In the Application of)
Inventor: Rene Langhans) Examiner: C. Goodman Group Art Unit: 3724
For: ROTARY CUTTING UNIT) Gloup Art Ollit. 3724
Serial No.: 08/883,685)
Filed on: June 27, 1997) File No. 2821-193

PETITION TO THE COMMISSIONER

Fig. 2

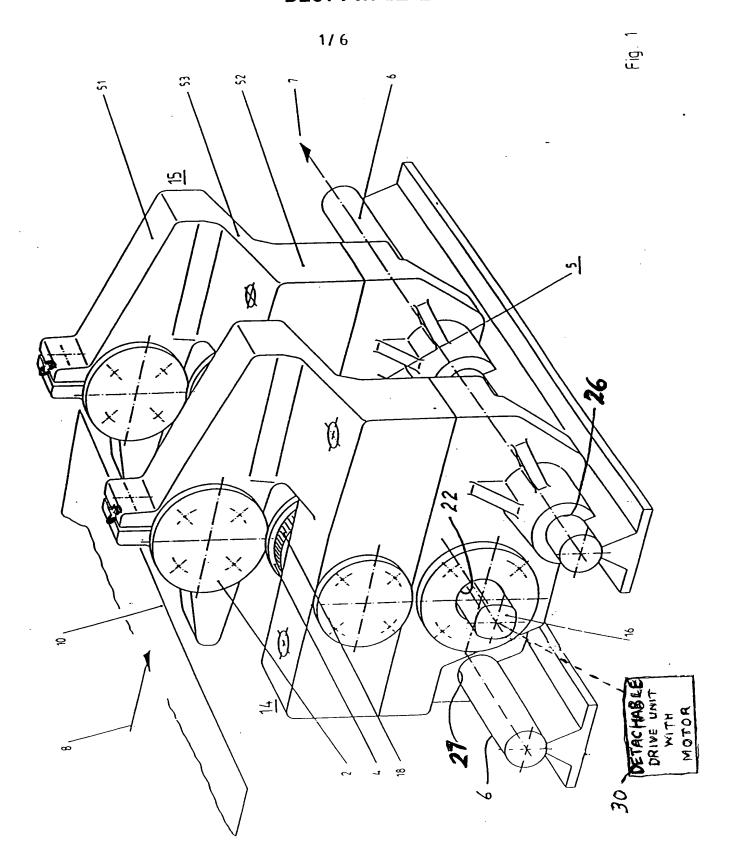
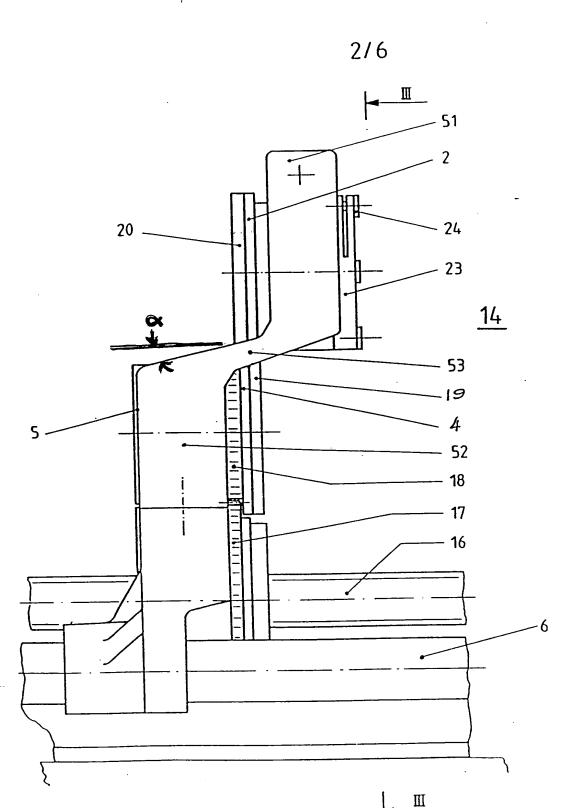
OBJECTIONS 1 and 4: Angle α identified in the specification but not shown in the drawings (See specification, Page 5, line 24);

OBJECTION 2: Examiner objects to reference numerals "26" and "27" in Figure 1 which should be interchanged.

ADDITIONAL AMENDMENT: Figure 1 was amended to include the slot for receiving pin wrench 25. (The slot for receiving pin wrench 25 was included in the original application in Fig. 4 as described below in paragraph 4.)

APPLICANT'S AMENDMENT: Figure 2 was amended by adding the symbol " α " and appropriate lead lines;

APPLICANT'S AMENDMENT: Figure 1 was amended by interchanging reference numerals "26" and "27".

In response to paragraph 4 - 6 of the Office Action dated March 8, 2000, revised informal Figures 1 and 2 are enclosed which identify angle α and switch the references to components 26 and 27. The labeling for drive unit 30 has been changed by adding the word "detachable," and a slot for the pin wrench has been added to the cutter frame 51. The changes are marked in red. No new matter has been added to the drawings by this revision.

Fla. 5

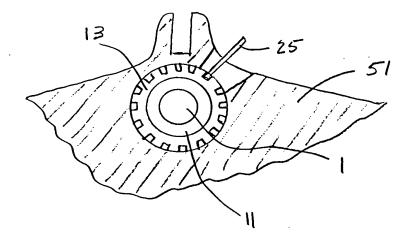
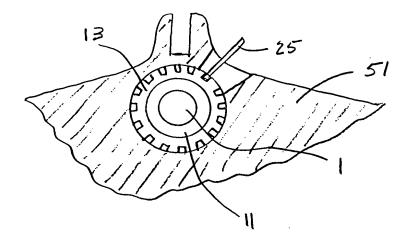
5) Entry of Applicant's Proposed New Figure

Applicant's proposed new Figure 5 (attached hereto as Exhibit D) should also be entered in the application. The proposed new figure is merely a detailed cross-sectional drawing of the displacement bush 13 within the frame 51 and the pin wrench 25 shown interior to the slot for receiving the pin wrench. Each element shown in the proposed new figure is disclosed in the original specification. Applicant's proposed new figure was drawn specifically to clarify the Examiner's understanding of the use of pin wrench 25 to adjust the cutting gap between cutting blades 2 and 4. The Examiner rejected the proposed new figure citing new matter. Again, apparently the cause of the confusion may be that the new figure shows the slot for receiving pin wrench 25 in a view perpendicular to Figure 4 and it appears different to the Examiner. However, Applicant's new figure does not include new matter. The detailed drawing to visualize the arrangement disclosed may be helpful for the Examiner and the Applicant has complied by producing the new figure. Applicant now requests the Commissioner to instruct the Examiner to enter the new figure in the application as matter well known to those skilled in the art.
